# Borderland

City Plan Commission — June 5, 2025

**CASE NUMBER/TYPE:** SUSU25-00016 – Major Combination  
**CASE MANAGER:** Myrna Aguilar, (915) 212-1584, [AguilarMP@elpasotexas.gov](mailto:AguilarMP@elpasotexas.gov)  
**PROPERTY OWNER:** Proyecto II, LLC  
**REPRESENTATIVE:** SLI Engineering, Inc.  
**LOCATION:** North of Borderland Rd. and East of Westside Dr. (Extraterritorial Jurisdiction (ETJ))  
**PROPERTY AREA:** 17.70 acres  
**VESTED RIGHTS STATUS:** Not Vested  
**PARK FEES:** \$113,710.00  
**EXCEPTIONS/MODIFICATIONS:** Yes, see following section  
**ZONING DISTRICT(S):** N/A Property lies within ETJ

## BORDERLAND SUBDIVISION

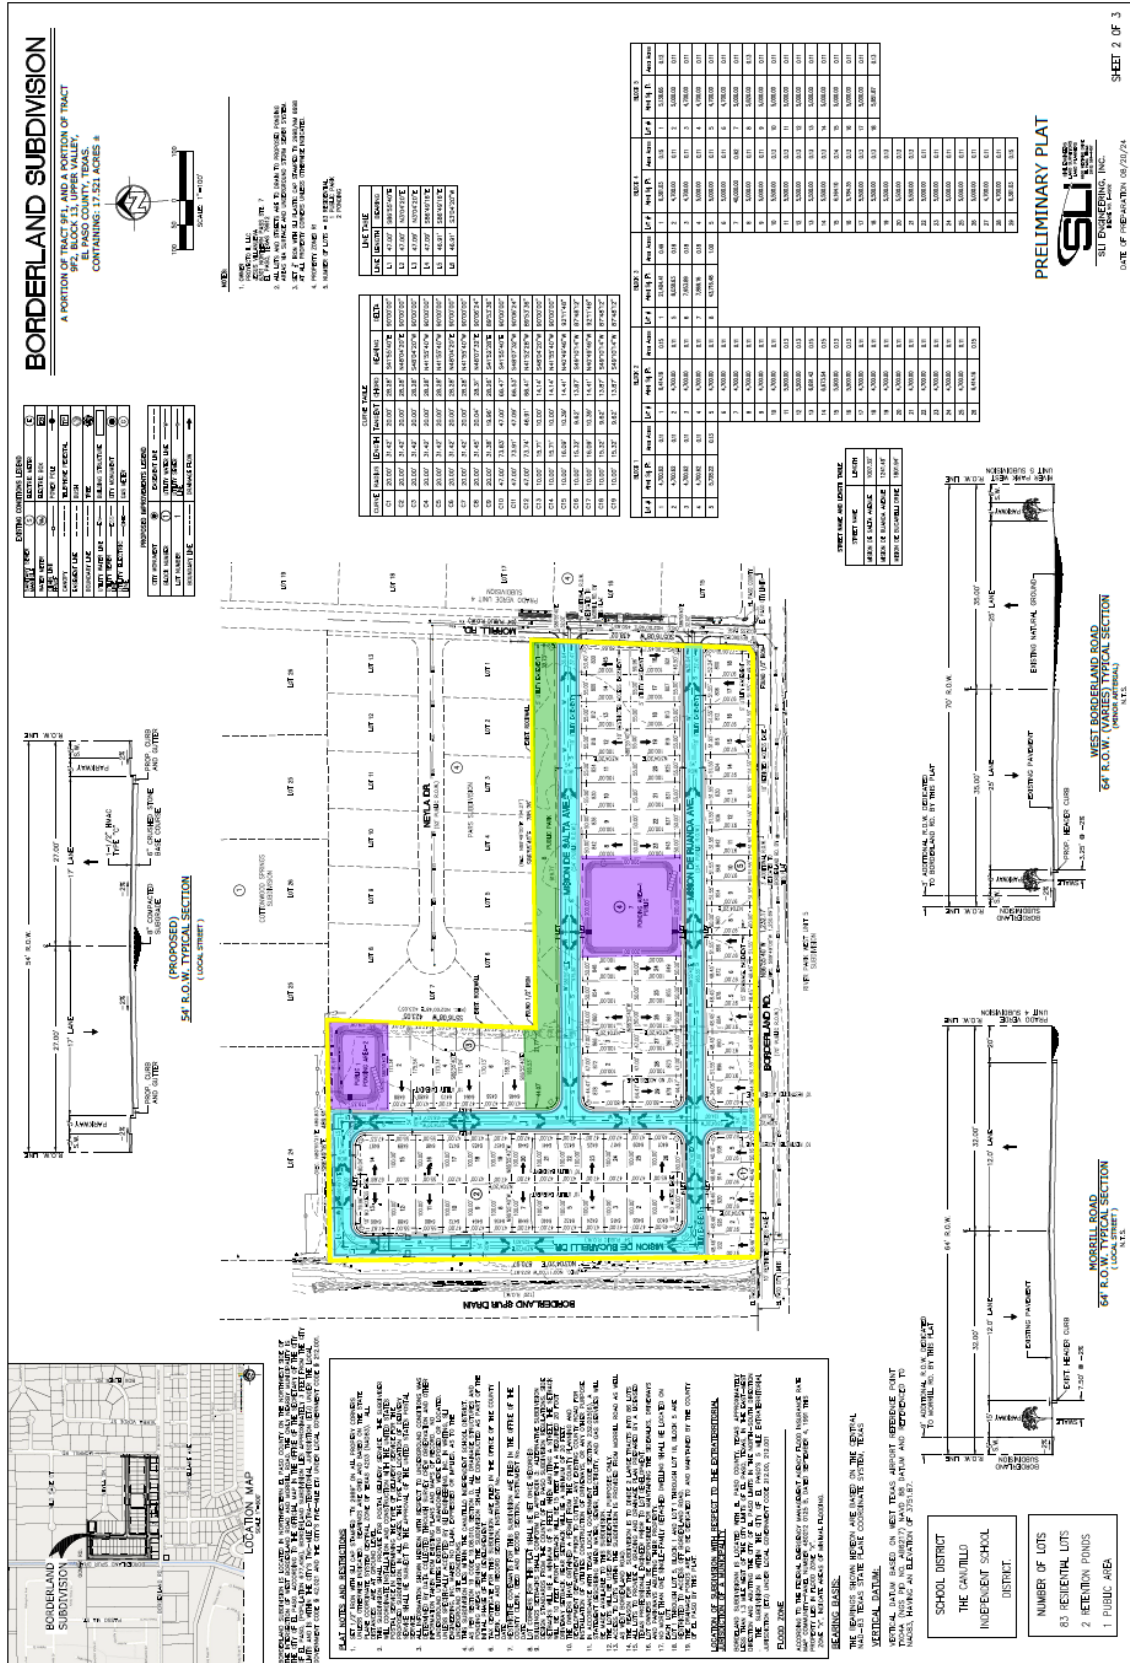
3. Please remove the word “subdivision” from subdivision name.
4. Add square footage and acreage to every single lot.
5. Please verify all proposed addresses correct. Block 3, Lot 4 has an odd number in comparison to the rest of the block. El Paso County 911 District has proposed addresses for Block 2, Lots 1 to 13.

1. The property area will be in the Flood zone according to the preliminary future FEMA maps. Meaning; that according to current maps from FEMA, the property is not in the flood zone area, but the property will be in the flood zone area in the future when new maps become effective. it is recommended to build 1foot above the preliminary BFE for on the affected lots.
2. Add general note to both the preliminary and final plat sheets: “The retention of all storm-water runoff discharge volume is required within this subdivision's limits in compliance with all provisions of (Muni-Code 19.19.010A, SDM, and DDM Section 11.1).”
3. Coordinate improvements with the El Paso County.
4. Boundary closure report is ok.
5. Provide and label private drainage easement in case needed.

- Please add a 10' wide easement along Borderland Rd, we have an existing line.
- Please change the restricted easement to a 10' wide utility easement along Morrill Rd, we have an existing line.
- Please add a 10' wide utility easement along the proposed ponding.
